RE: 17TH STREET CANAL PARALLEL FLOOD PROTECTION
PHASE 1B - HAMMOND HIGHWAY TO SOUTHERN RAILWAY
OLB PROJECT NO. 2043-0207

In your letter of October 21, 1988, you listed comments on our preliminary plans for the above referenced project. In our review of those comments, we discovered that the slope stability calculations for the first six reaches of this project do not properly reflect the actual factors of safety.

We are submitting revised slope stability and sheet pile analyses for Reaches 1 through 6 which supersede the previously submitted calculations and consequently make obsolete comments "a" and "b" of your letter of October 21, 1988.

REACH 1
STA. 553+70 TO STA. 568+00

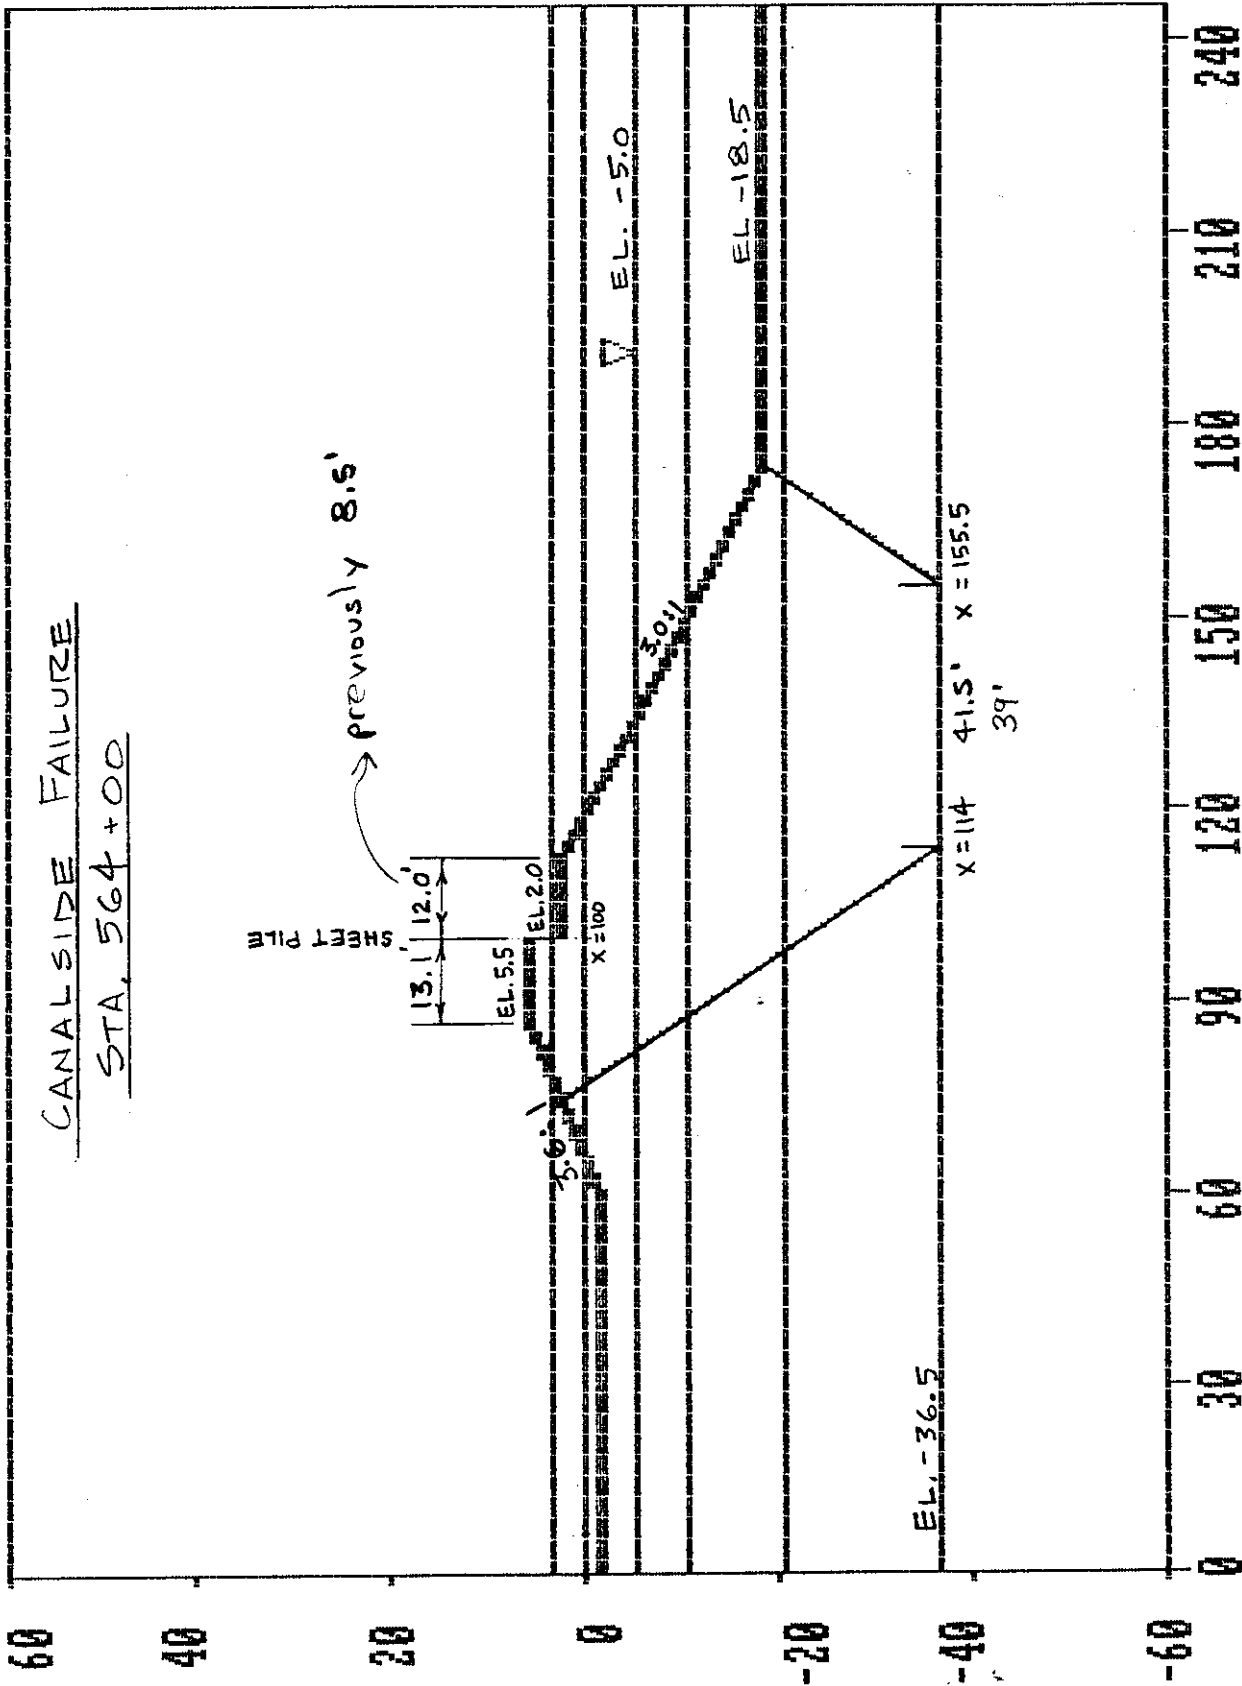
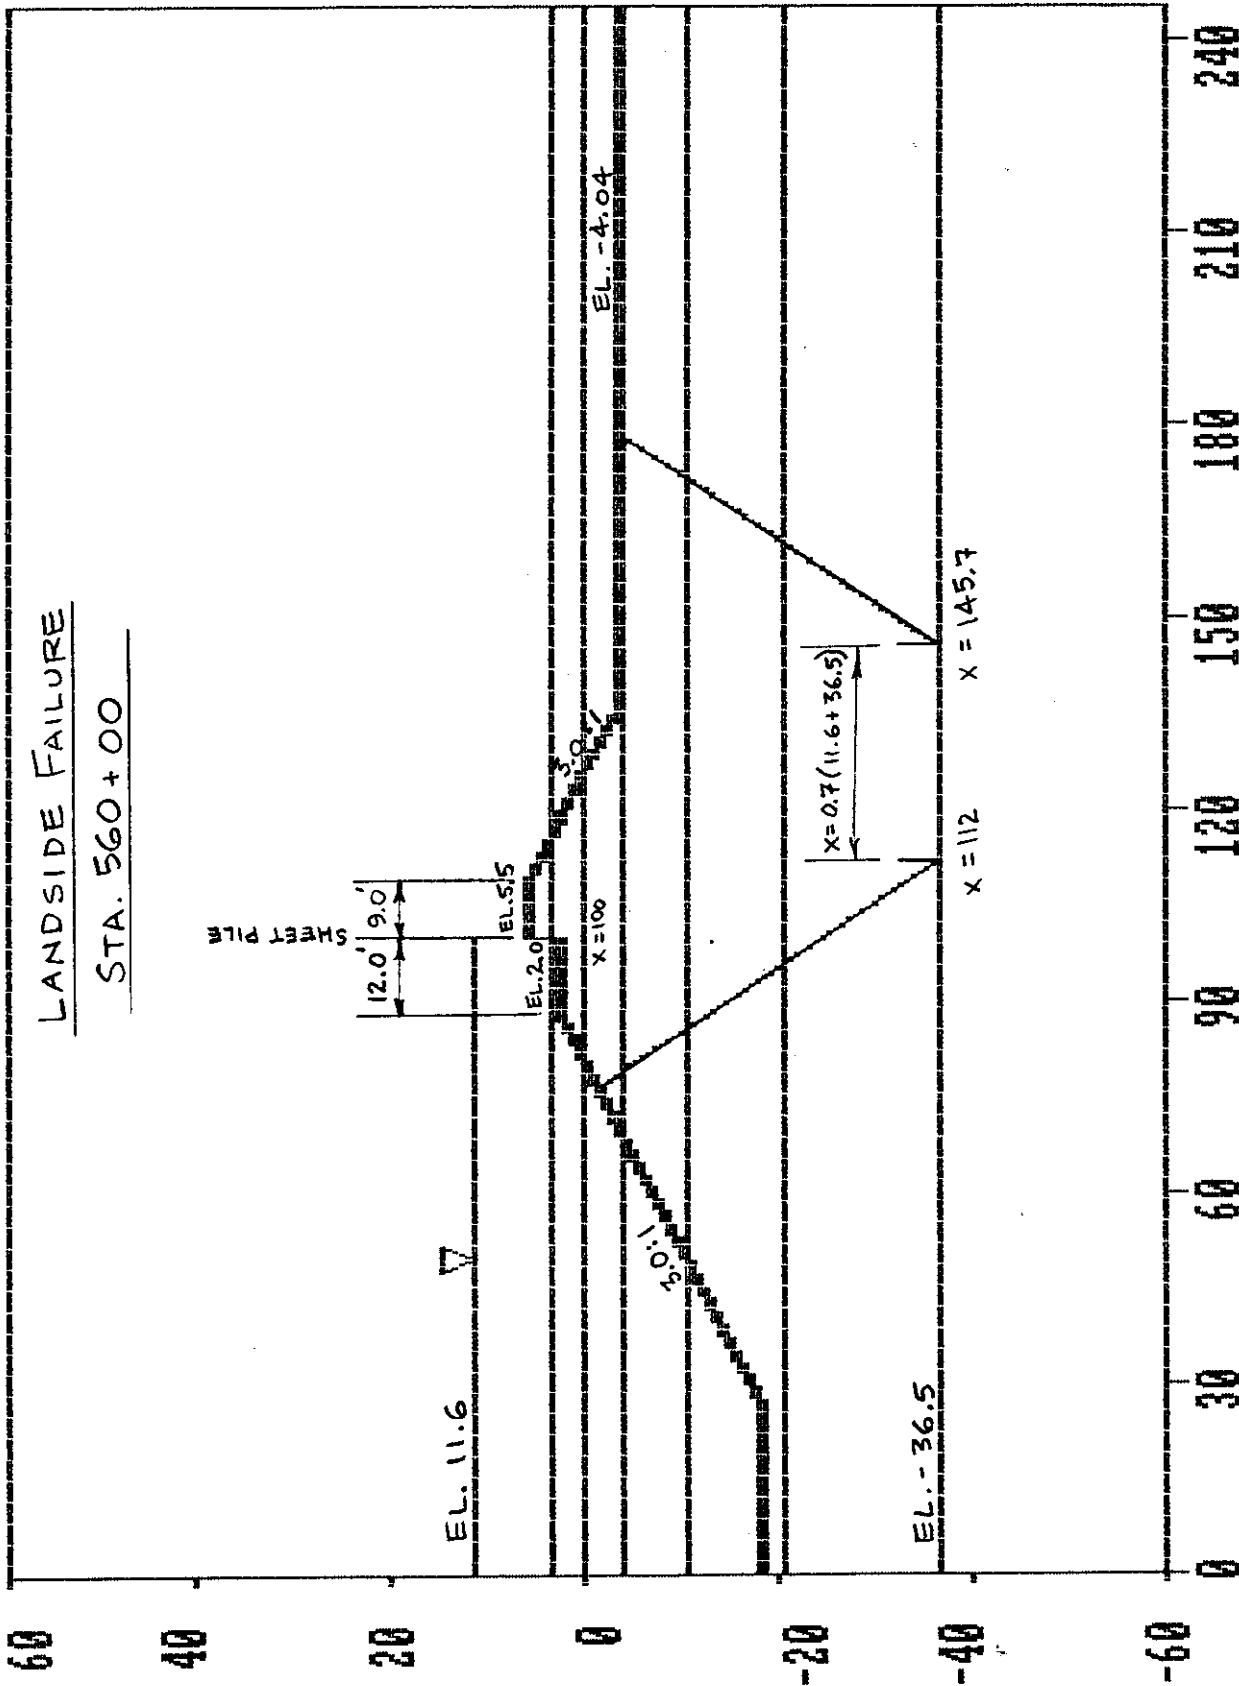
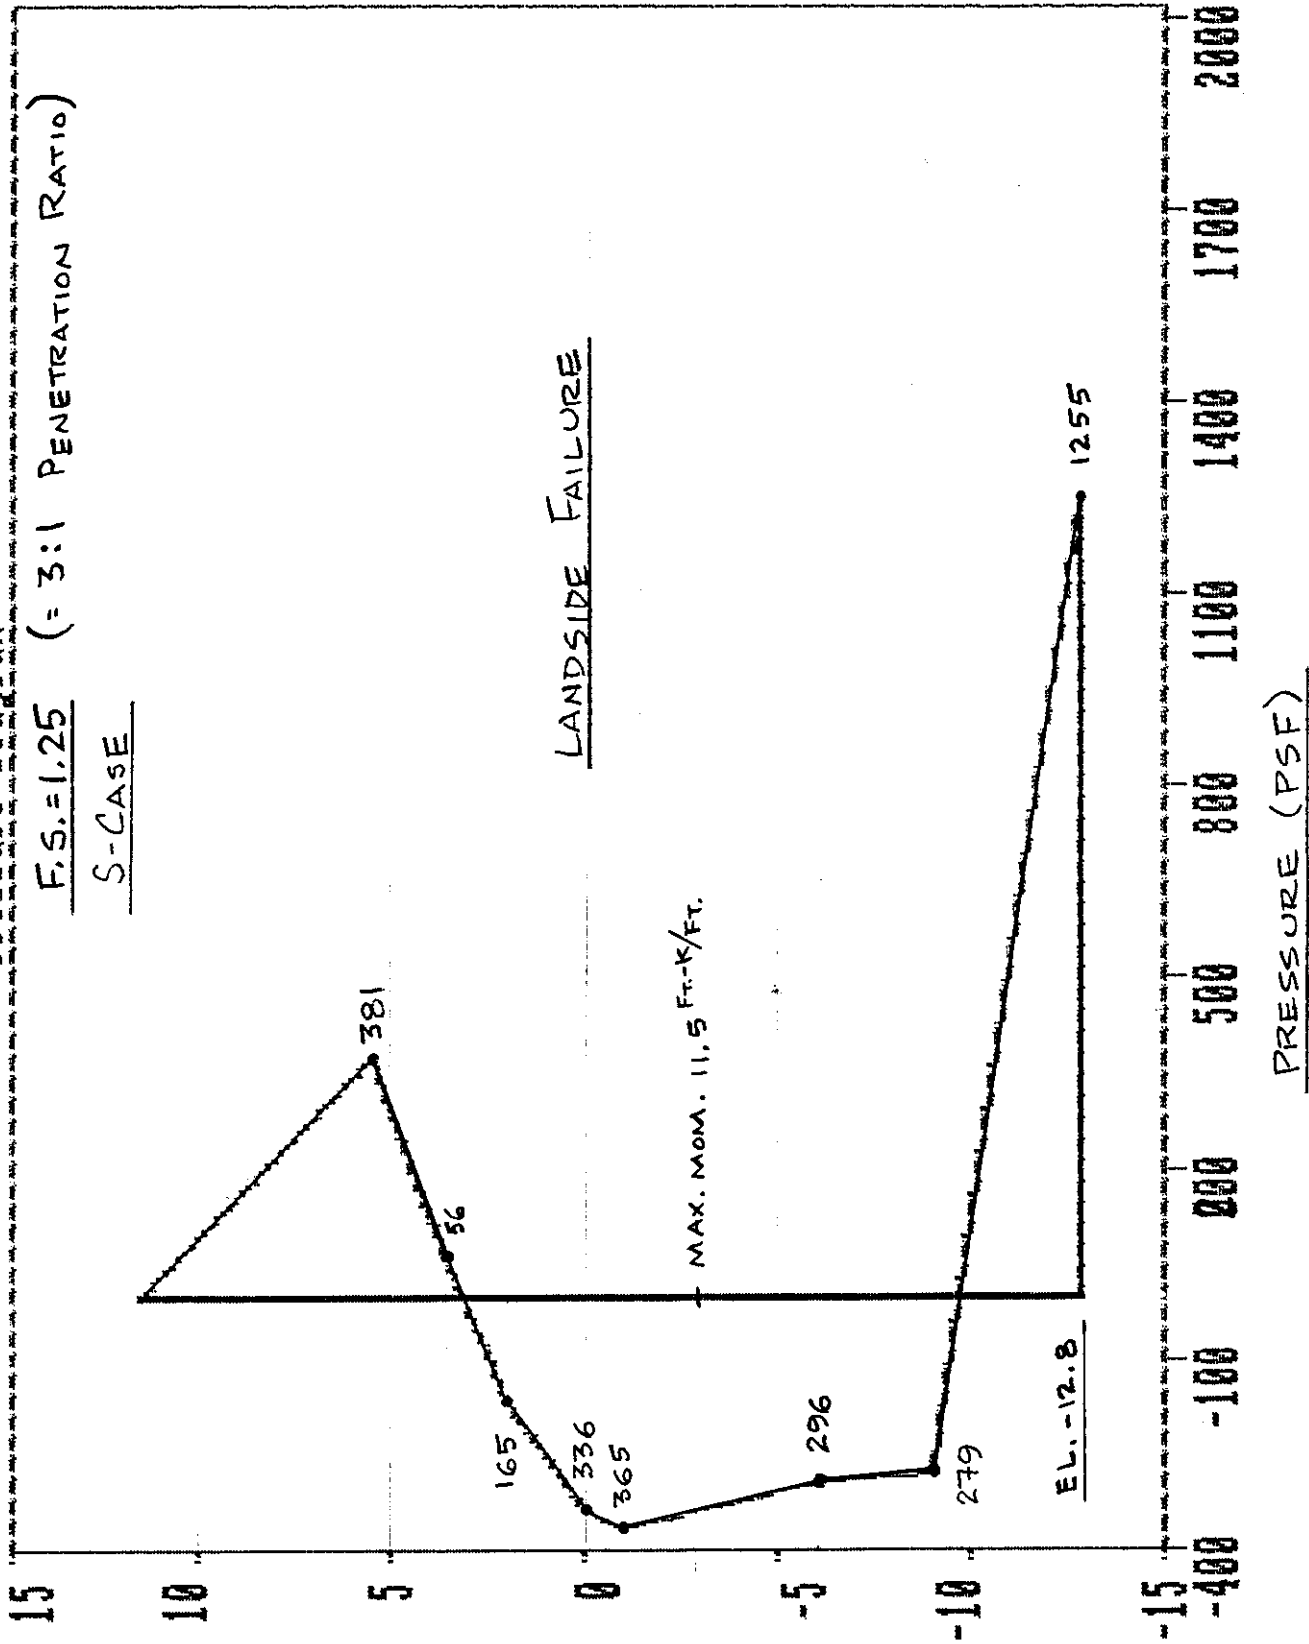
Revisions to Cross-Section : Realign Sheet Pile
Increase Step Width to 12.0' (Hold Elevation at 2.0)

GDM section is a minimum composite with a 9' for I-wall crown width and a bench @ EL 2.0 with a maximum crown width of 11.5'. Tip EL -12.74 3:1 (F.S.=1.32)

Canalside Failure - 562+00, 564+00 and 566+00. The section at Sta. 564+00 governs.
*** Minimum Factor of Safety = 1.30 ***

Landside Failure - 554+00, 556+00, 560+00 and 562+00. The section at Sta. 560+00 governs.
*** Minimum Factor of Safety = 1.33 ***

Required Penetration : -12.8 (Landside Failure 3:1 Ratio; S-Case F.S. = 1.25)
Design Bending Moment : 11.5 Ft-K/Ft @ EL. -2.8 (Landside Failure 3:1 Ratio; S-Case F.S. = 1.25)
Maximum Deflection : In.
